REZONING PLAN	SHEET NO. 12	REC-1
	307559

PETITION NO: Z-6

PROPOSED ZONING: R-15

PROPOSED USE: Subdivision

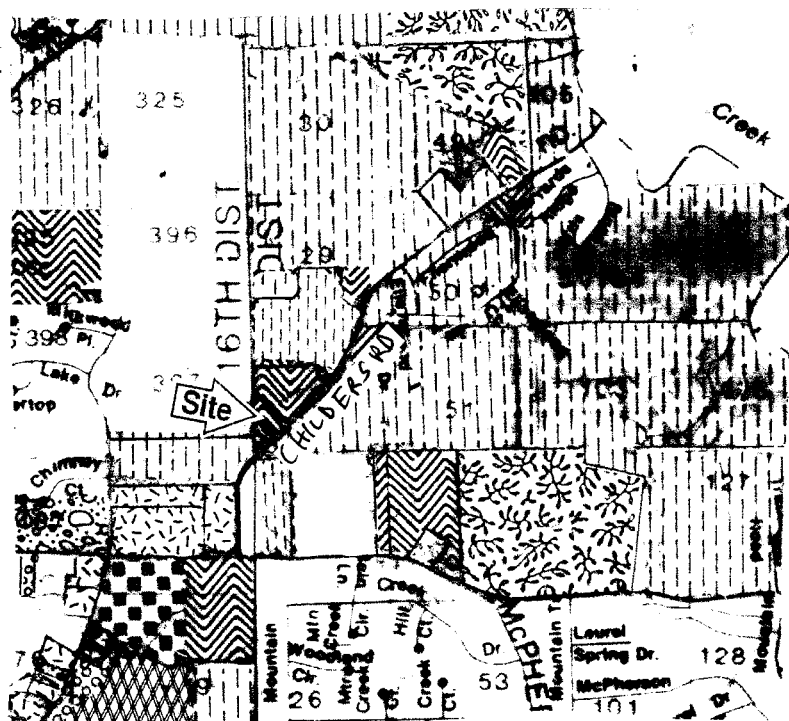
1. As indicated in the Downstream Conditions Comments, Lower Chimney Lake is located approximately 600 feet downstream from the site. A pre- and post-development sediment study will be required.
2. The proposed detention pond is located immediately to the rear of two existing homes within the adjacent Chimney Lakes S/D. The landscape plan must include suitable vegetative to provide adequate screening for these existing home owners. If a wall is required to meet detention requirements, the wall must be decoratively faced with masonry or form-liners used to provide an aesthetic view.
3. The detention pond lot must be extended with a 20-foot “ flag” to the public R/W to provide adequate pond maintenance access.
